STATE OF NORTH CAROLINA
DEPARTMENT OF TRANSPORTATION

Subject: **Request for Permit Modification** for TIP No. U-2307 AB, Catawba County, Hickory East Side Thoroughfare; State Project No. 8.2790906; Federal Aid Project No. STP-5621(6), Division 12.

The U.S. Army Corps of Engineers (USACE) issued a Section 404 Individual Permit (IP) to the North Carolina Department of Transportation (NCDOT) on October 26, 2001 for construction of the Hickory East Side Thoroughfare, from north of interchange at I-40 to SR 1453 (Springs Road). The purpose of this letter is to request a modification of Permit Site Nos. 11 & 12.

PLAN VIEW
 SITE 11

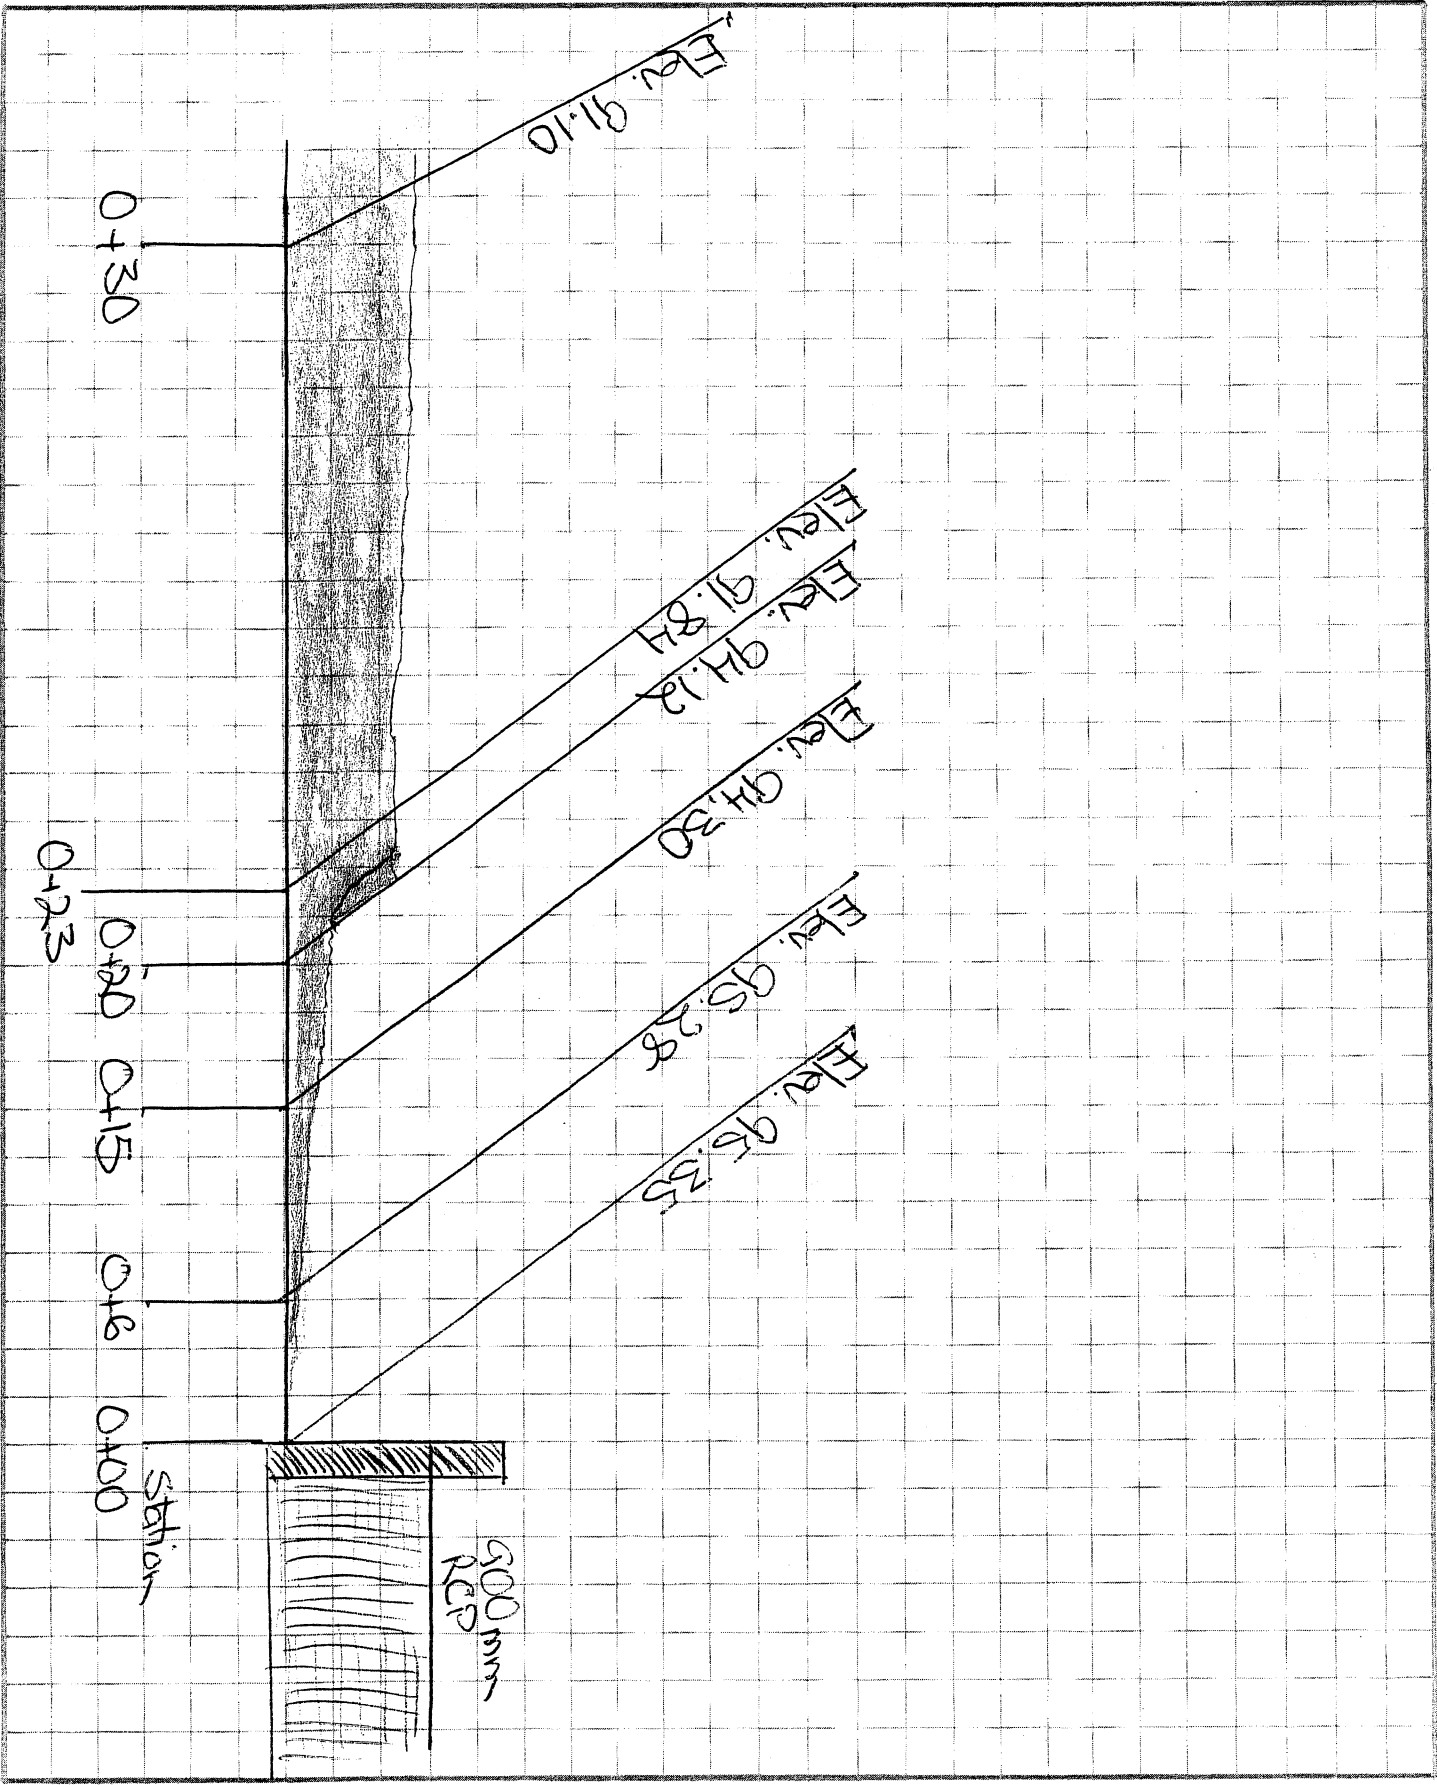
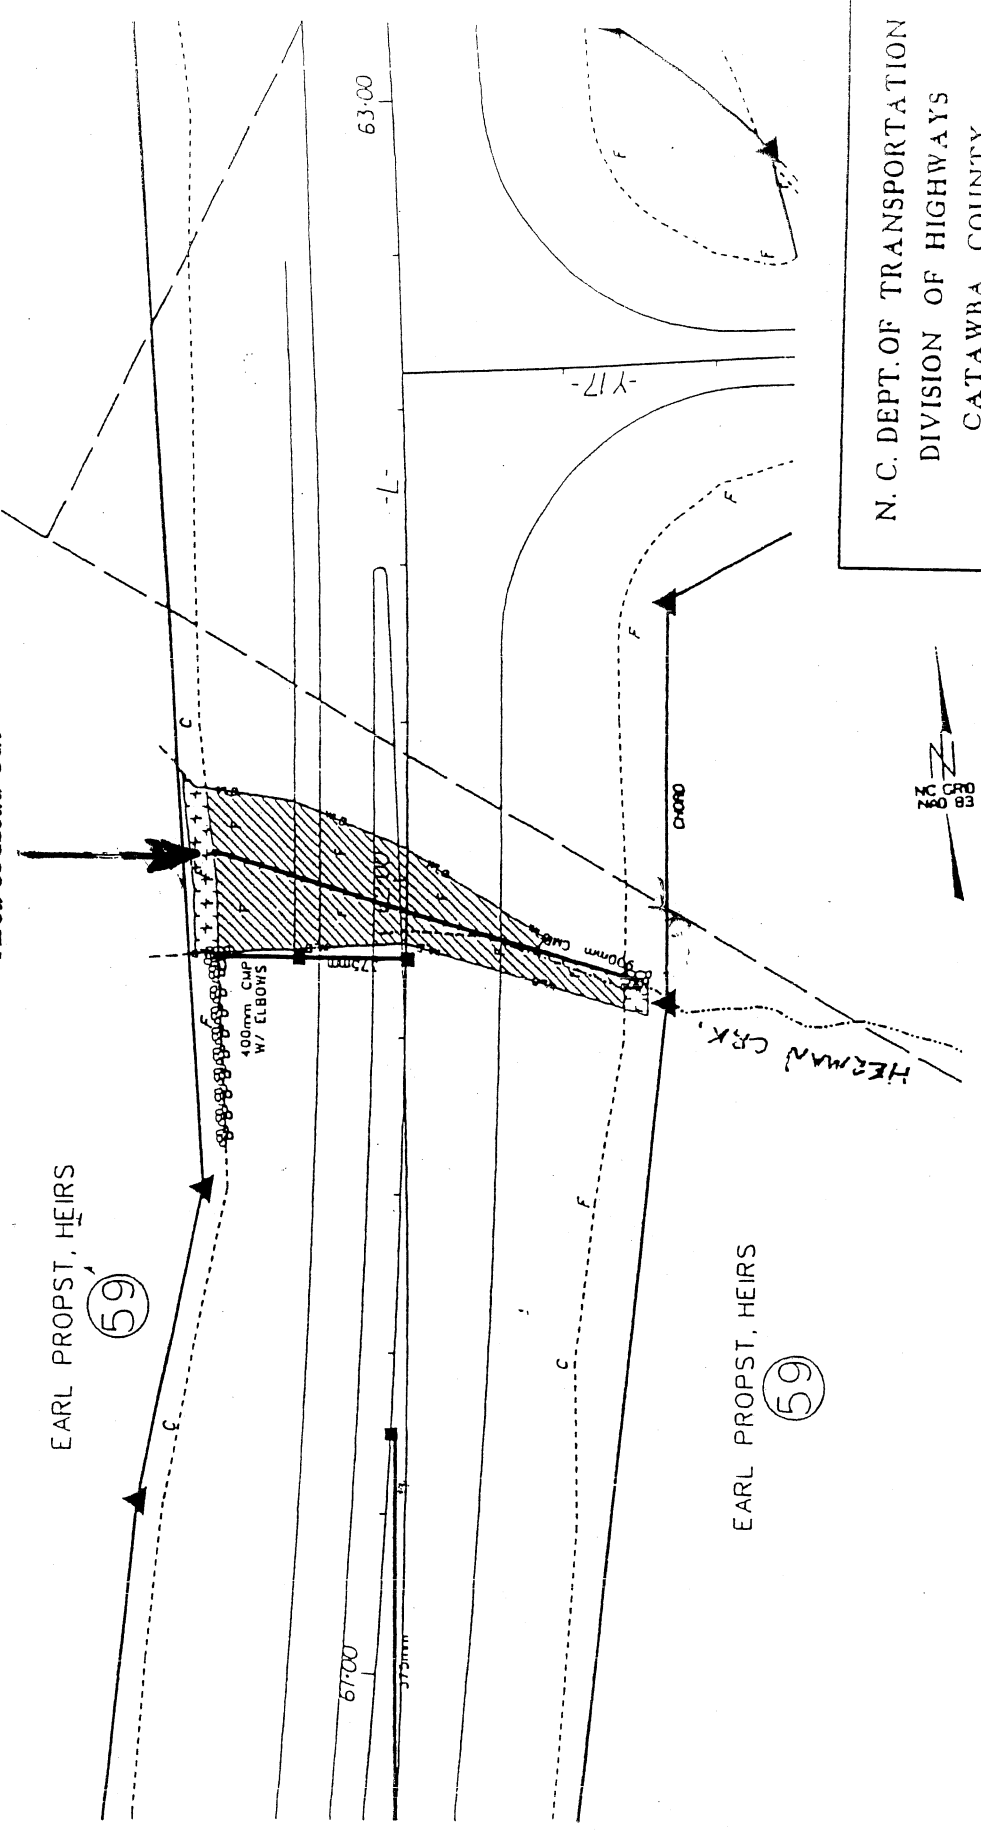
At Permit Site Nos. 11 & 12, it is proposed that two rock cross vanes be constructed in a series, at each site, to provide better grade control and better accommodate aquatic passage. The use of two rock cross vanes at each site has been chosen because of the severity of the head-cuts (2.28 feet @ site no. 11 and 2.86 feet @ site no. 12) and the small nature of the streams.
